ABINGTON TOWNSHIP

BOARD OF COMMISSIONERS REGULAR PUBLIC MEETING

**RE: Executive Summary for LD-25-01 – 1526 Fairview Avenue
PARID: 30-00-18860-00-1/ TMID: 30196 017
Preliminary/Final Major Subdivision & Land Development Plans Review (2nd Submission)**

LD-25-01 PRELIMINARY/FINAL MAJOR LAND DEVELOPMENT PLANS

RECORD PLAN (SHEET 1 OF 1 TO BE RECORDED)

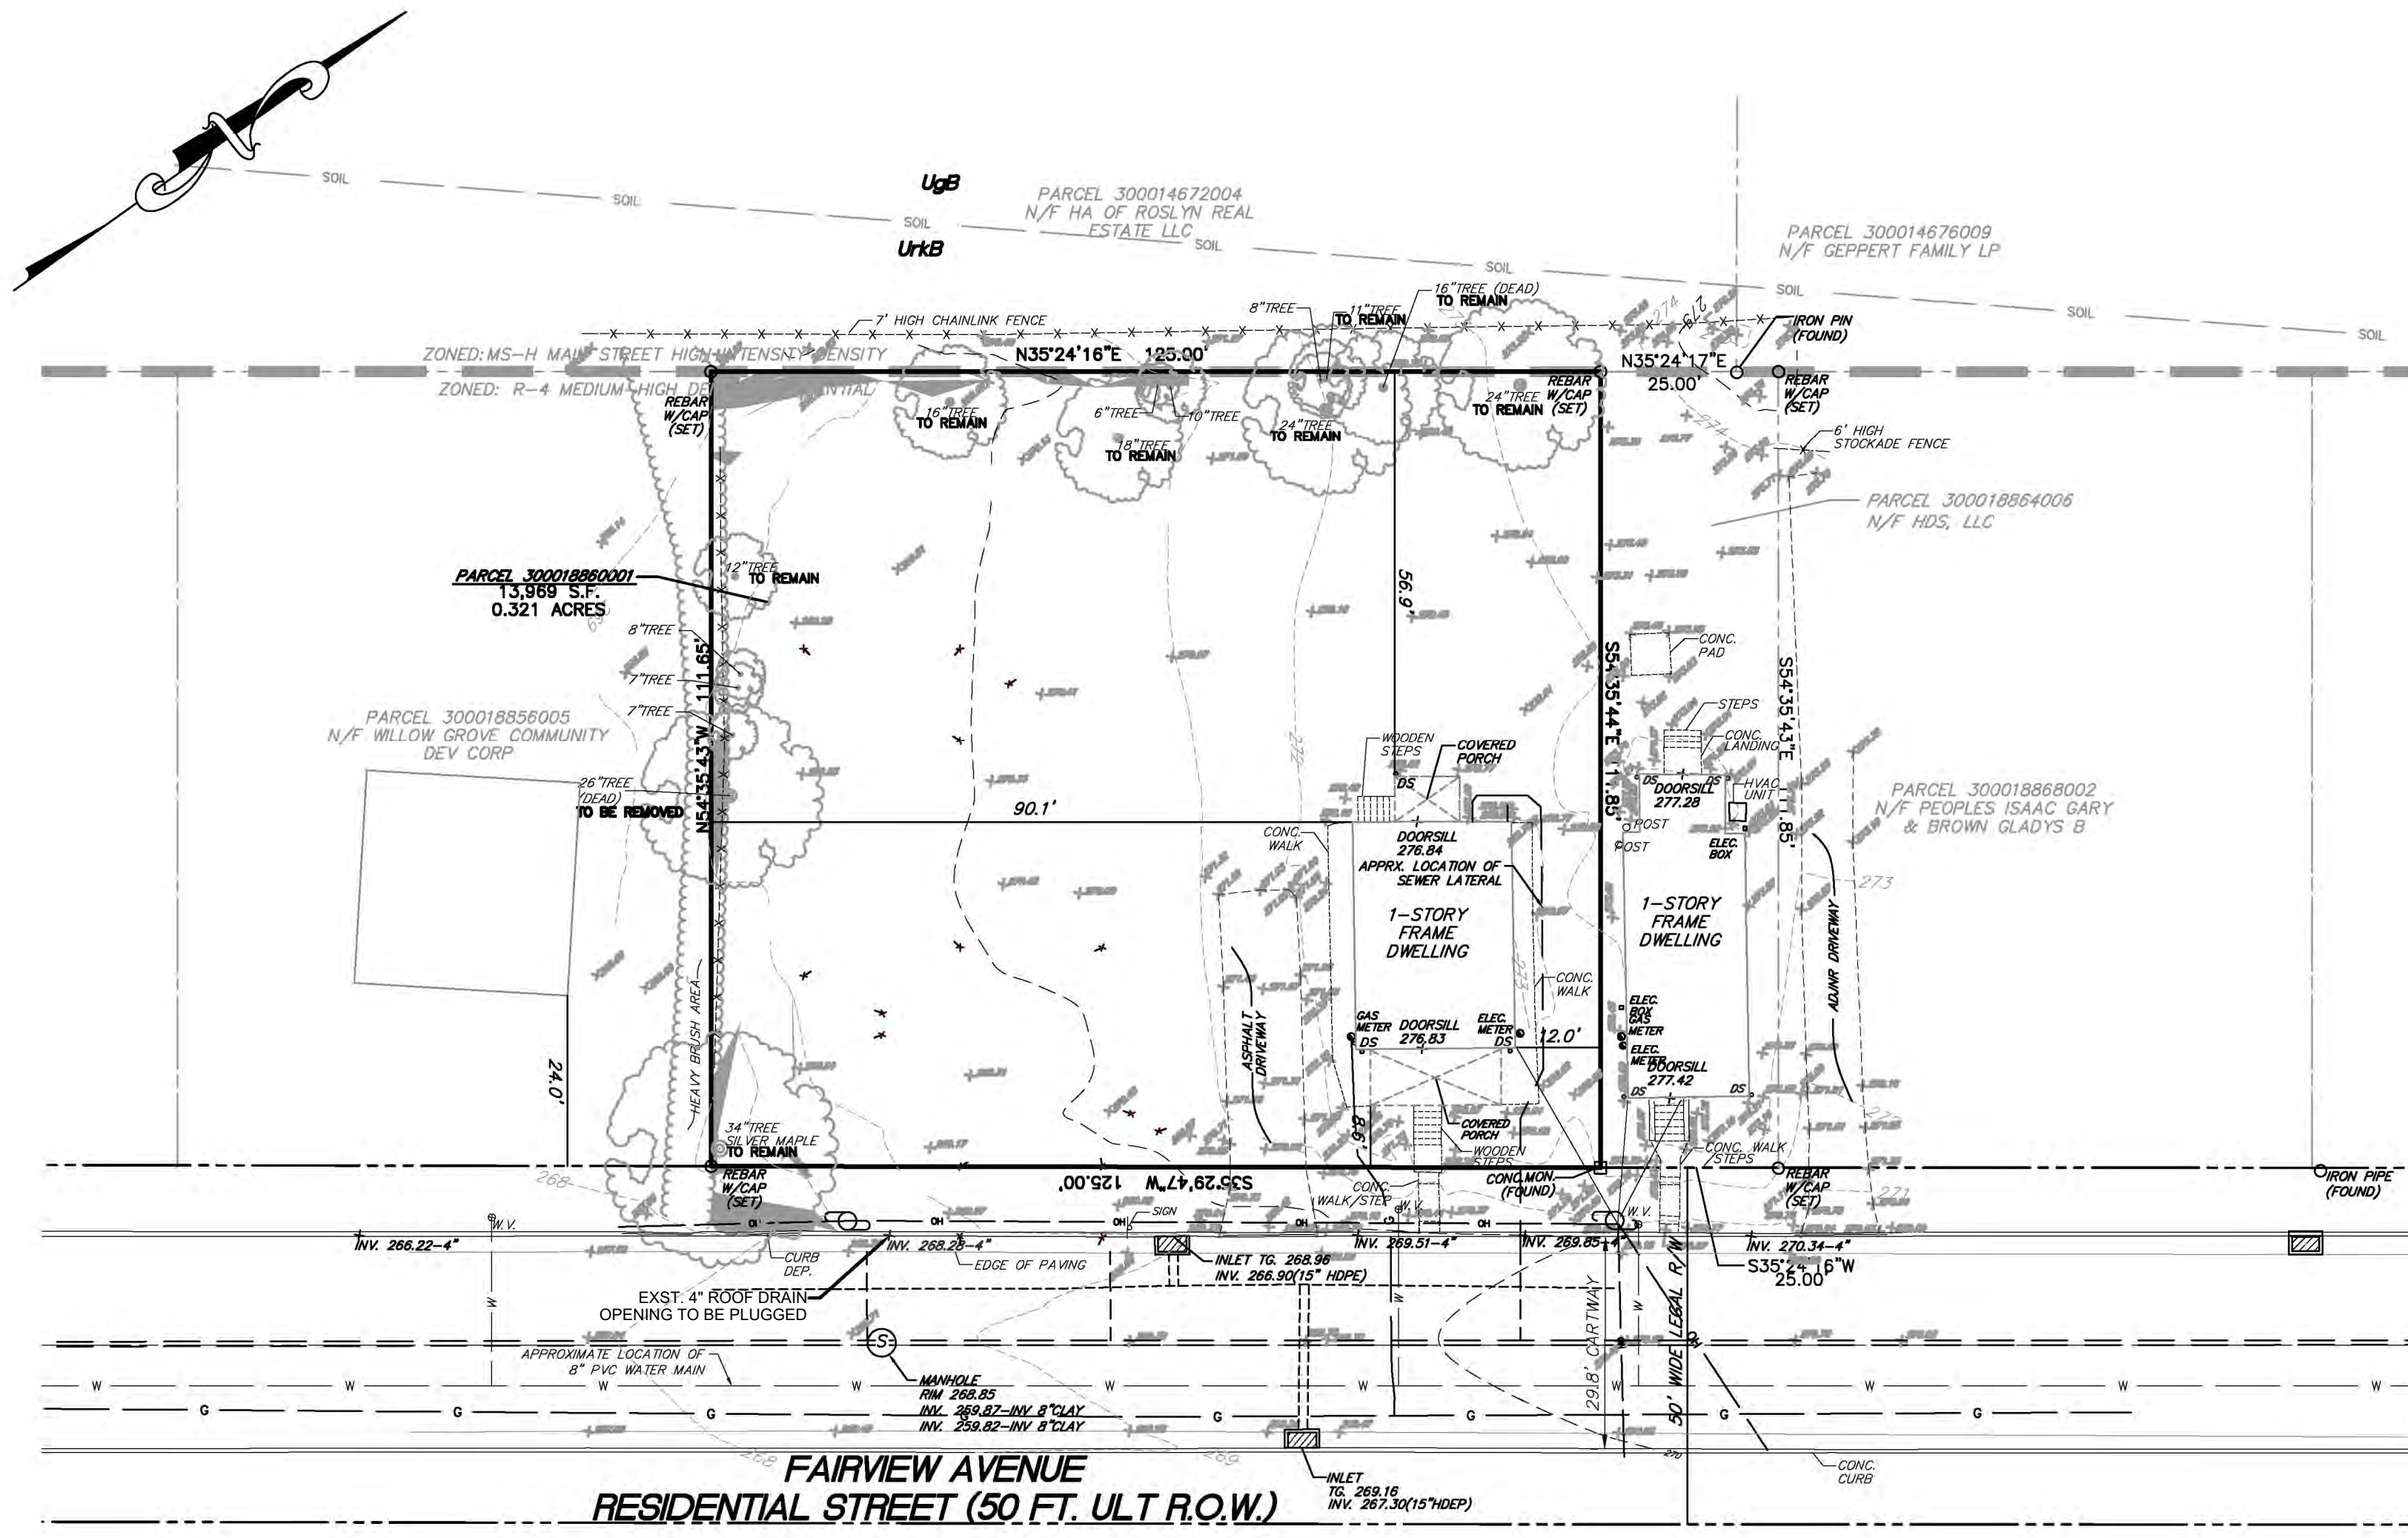
The condition of approval for the above variances shall be included on the Record Plan (Sheet 1).

Provide additional room for the seal of the Township Engineer to ensure no text overrides with the secretary’s signature line above in the “Board of Commissioners Approval” signature block on the Record Plan (Sheet 1).

4. Plan sheets to be recorded shall be indicated on the Record Plan (Sheet 1). Plans to be recorded shall include Sheets 1, 3, 4, and 8.

This waiver request shall be revised on the waiver request letter and the Record Plan (Sheet 1) to indicate the correct Code Section of §146-33.G instead of “§146-33(7)” which does not exist in the current SALDO code.

This waiver request shall be revised on the waiver request letter and the Record Plan (Sheet 1) to indicate the correct Code Section of §146-35.C.(1) instead of “§146-35(3)(A)” which does not exist in the current SALDO code.

52. The Index of Sheets on the Record Plan (Sheet 1) shall indicate which plans are to be recorded.
53. The narrow longitudinal zoning district abutting the R4 zoning district located to the east of the site on the Location Map is mislabeled as "MS-H" and should be corrected to the "MS-L" zoning district. Similarly, the "MS-H" label for the horizontal area between Arnold Avenue and Fairhill Avenue should also be corrected to the "MS-L" zoning district.

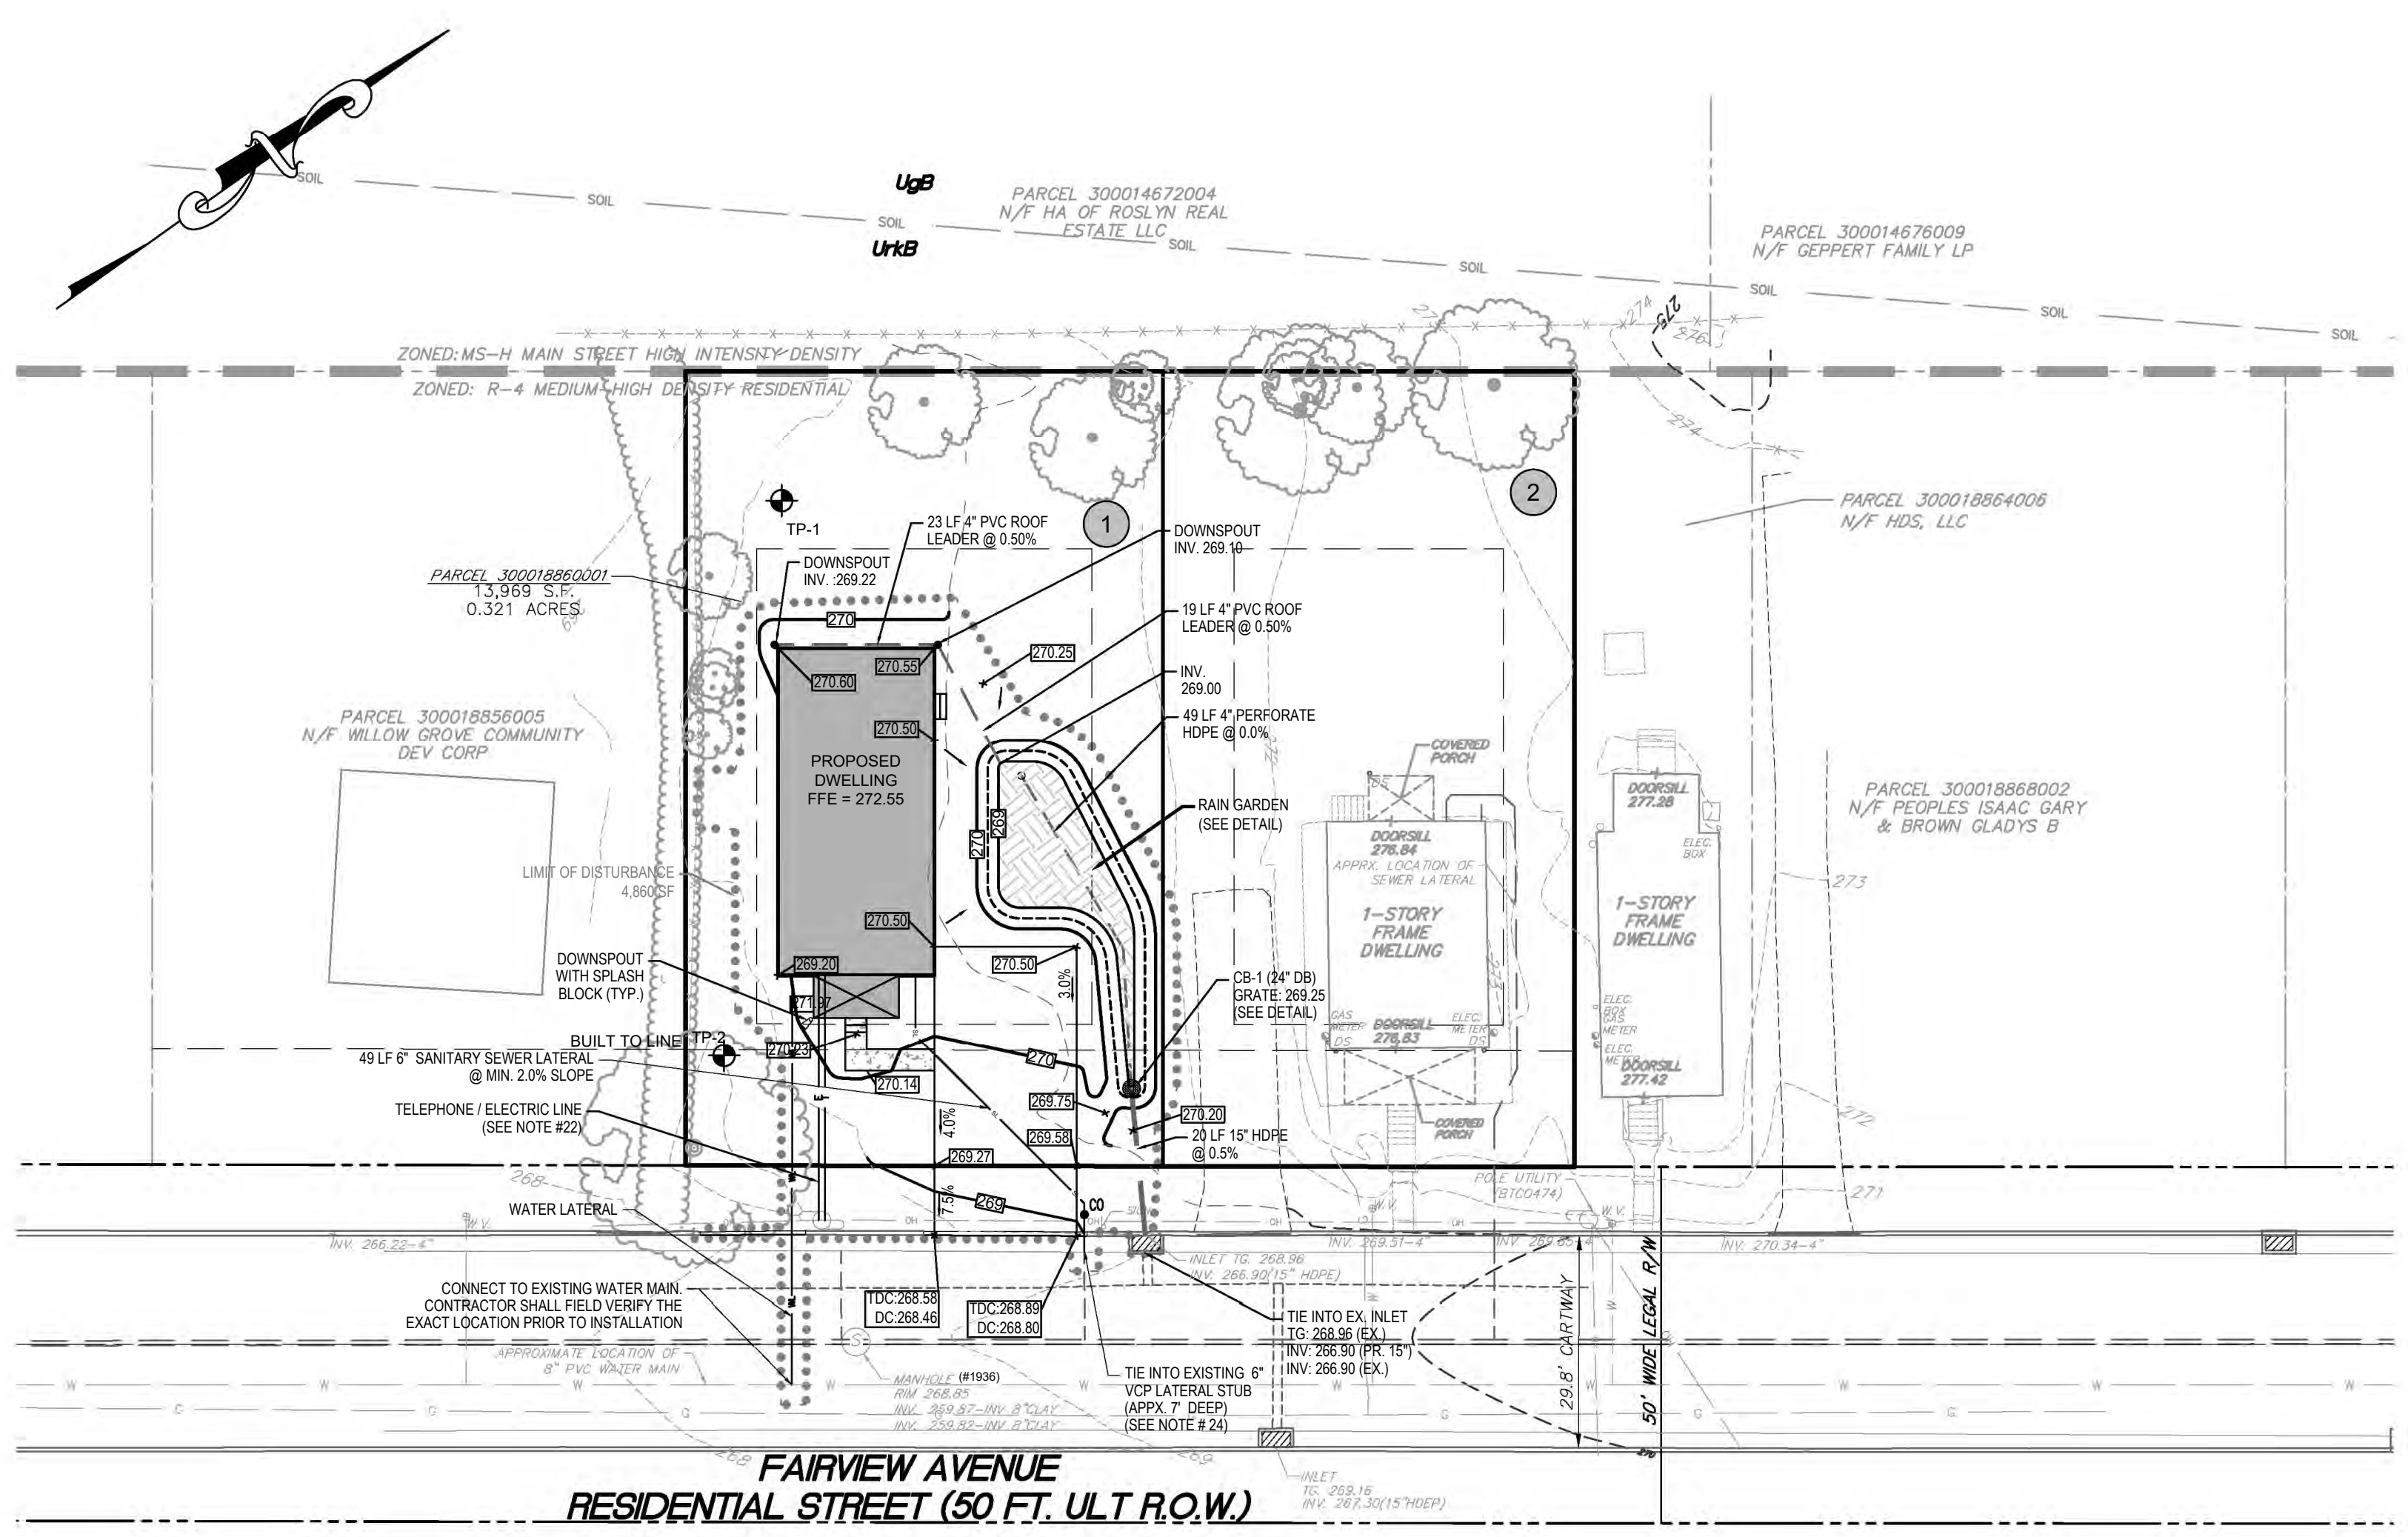
There are no existing precautionary (slopes of 15% to 25%) and prohibited (slopes of 25% and up) steep slopes on the site as shown on the Existing Features/Demolition Plan (Sheet 2); and therefore, the site will not be considered within the Steep Slope Conservation Overlay District, and the site is not subject to the Steep Slope Conservation Overlay District requirements. In addition, since the site is not located within the R1 – Low Density District, the site will not be subject to the Land Preservation District Overlay requirements.

Each mature tree with a 10-inch caliper or greater shall be clearly shown on the plans and indicated if these trees are to remain or to be removed on the Existing Features and Demolition Plan (Sheet 2).
